EE	DATE	POWER	DATE	INVENTEC			
DRAWER					TITLE DAVOS-DF			
DESIGN								
CHECK								
RESPONSIBLE								
SIZE = 3							VER :	
FILE NAME : XXXX-XXXXXX-XX					SIZE A3		CODE CS	DOC. NUMBER PC9603
P/N XXXXXXXXXXXXXX					SHEET 1		OF 65	
					REV		A01

IEC / HP Davos 1.0 Schematic Changes					PV-1			
HP Confidential Information						Last Updated: October 28, 2004		
Item #	Component / Subsection	PG. #	Description of Requested Change	Date Open / Closed	Requested By	Status	IEC FBK/Date	
1	ITP Conn (CN22)	19	Zone C6. Add 0.1uF no install capacitors pads to the following traces: H_TMS H_TCK H_TDO H_TRST# ITP_DBRESET Place the pads as close to the ITP conn as possible and keep the stubs as short as possible.	2004/9/17	BR	Open	Zone C6. Add 0.1uF no install capacitors pads to the following traces: H_TMS(C5003) H_TCK(C5004) H_TDO(C5005) H_TRST#(C5006) ITP_DBRESET(C5007) Place the pads as close to the ITP conn as possible and keep the stubs as short as possible.	
2	Alviso	22	Zone C6. Add 0.1uF no install capacitor to H_CPURST#. Place the pads as close to Alviso as possible and keep the stubs as short as possible.	2004/9/17	BR	Open	Add C5008 to H_CPURST#. But there is no place can put the pad

INVENTEC			
TITLE DAVOS-DF 6 IN 1 SLOT			
SIZE A3	CODE CS	DOC. NUMBER PC9603	REV A01

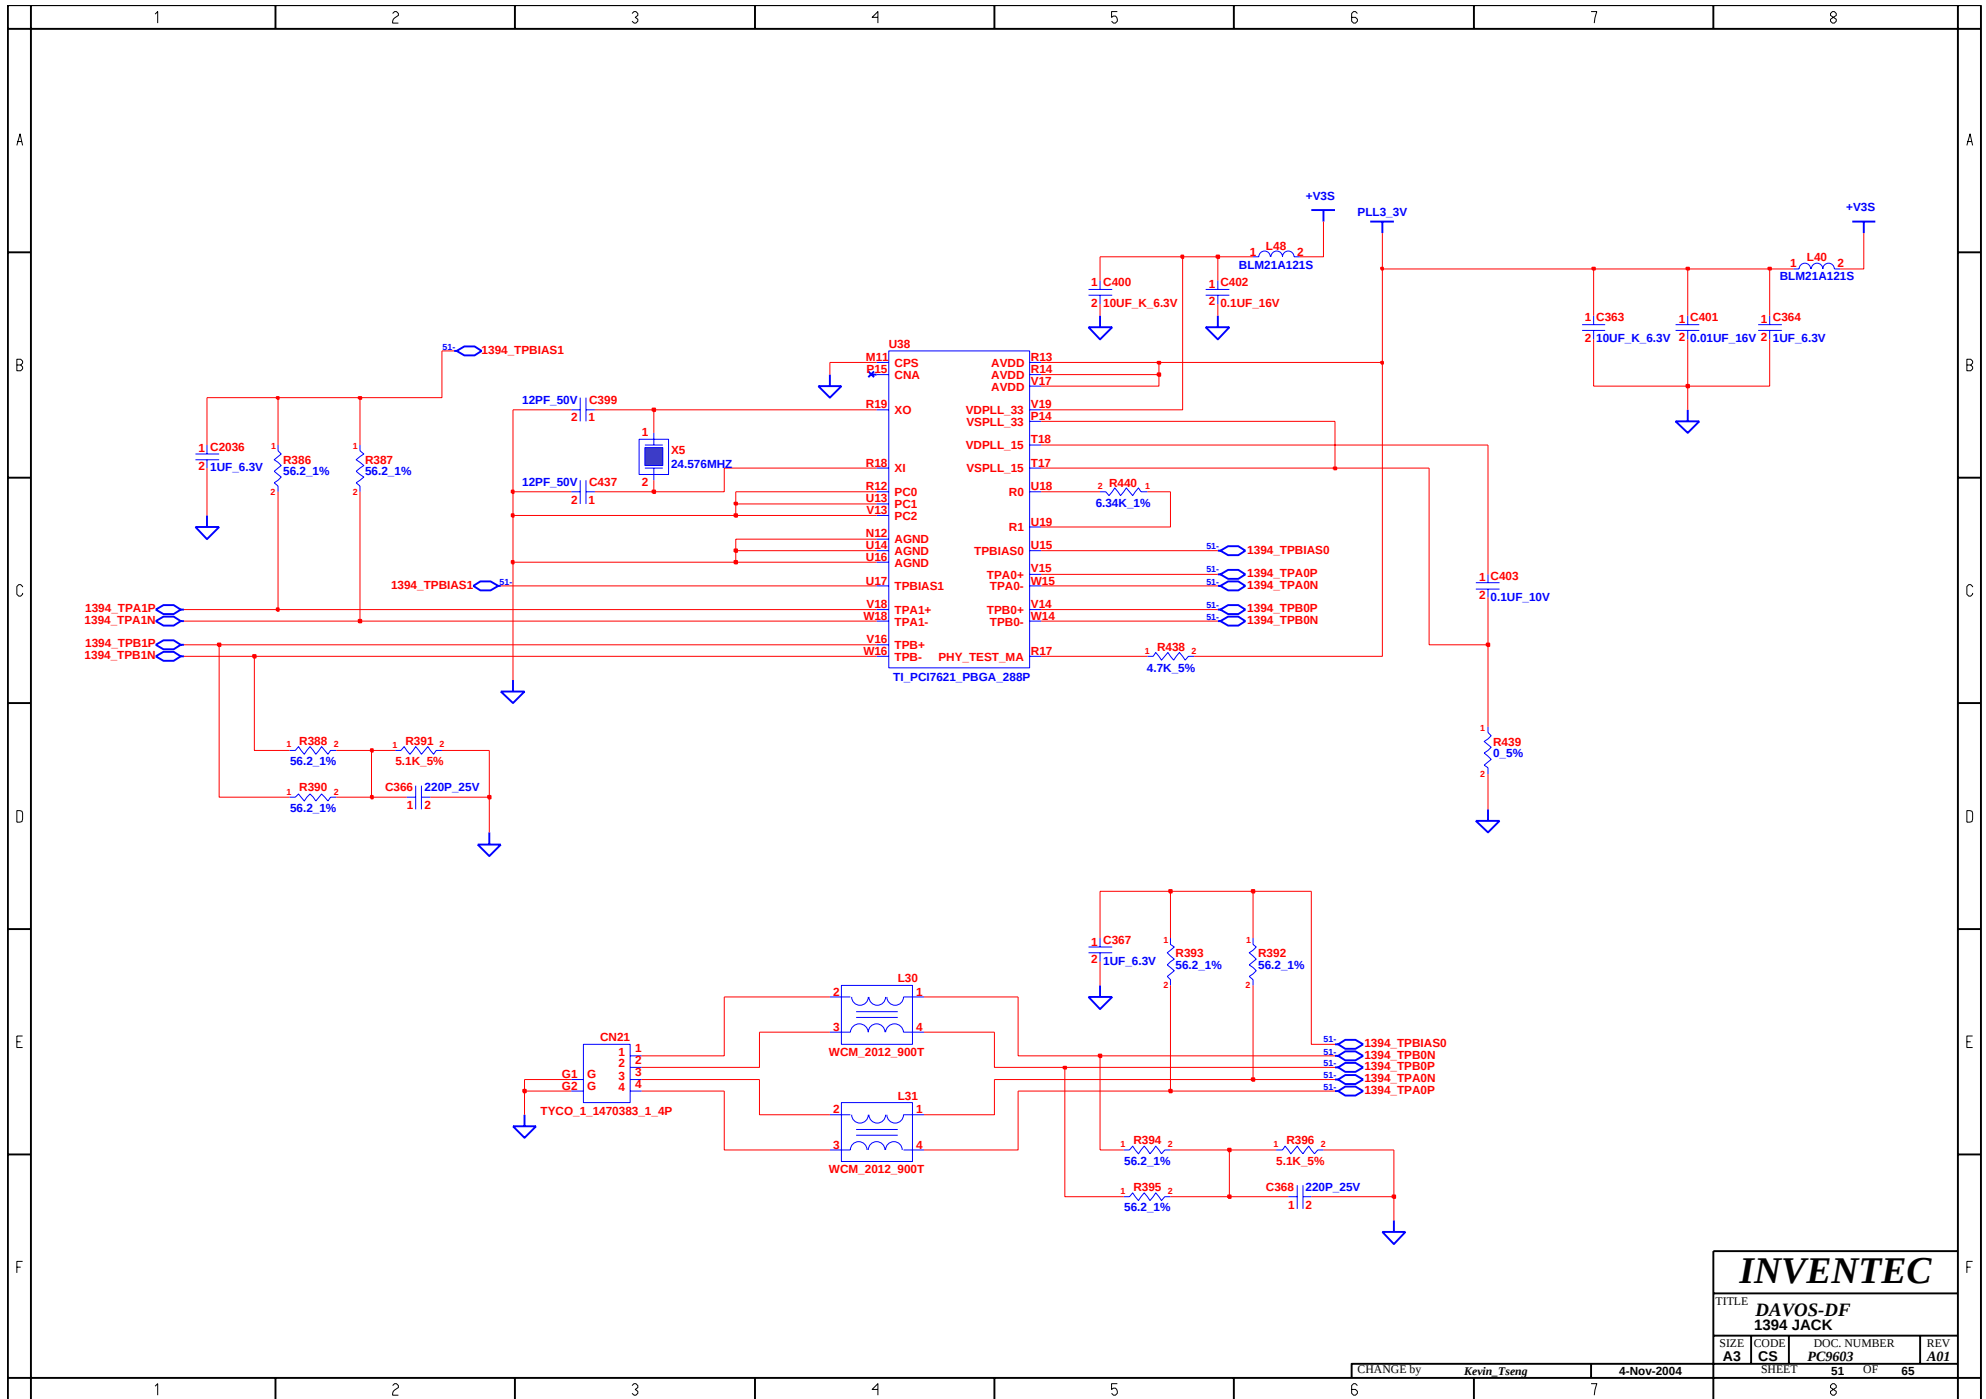
3	Wireless button	63	Zone F3, Delete pin2 & 4 of SW2 to ground, made it to NC.	2004/9/27	IEC	Open	Fixed in 0927.	
4	6 in 1	50	Change pin2&3 of U42, pin1 of R720 to from +V5S to +V3S.	2004/9/27	IEC	Open	Fixed in 0927.	
5	6 in 1	50	Zone D6, Exchange pin define of CN5001, pin20, pin21.	2004/9/27	IEC	Open	Fixed in 0927.	
6	Power	11	Zone B4, Change C198 to 4.7uF_6.3V-for GSM interference issue.	2004/9/27	IEC	Open	Fixed in 0927.	
7	Thermal	20	Zone D5, Change C290 to 4.7uF_6.3V-for GSM interference issue.	2004/9/27	IEC	Open	Fixed in 0927.	
8	CRT	30	Zone C1, Add three analog bus switches to the RGB lines going to the notebook CRT connector.	2004/9/17	HP	Open	Zone C1, Add three analog bus switches(U2001, U2002, U2003) to the RGB lines going to the notebook CRT connector.	
9	CLK gen	15	Zone C3, Change CLK_R3S_CBPCI from pin5(PCI5) of U30 to pin56(PCI2), Separate CLK_R3S_SIOPCI and CLK_R3S_FWHPCI from pin4(PCI4), and connect CLK_R3S_SIOPCI to pin5(PCI5) of U30.	2004/10/4	IEC	Open	Fixed in 1004.
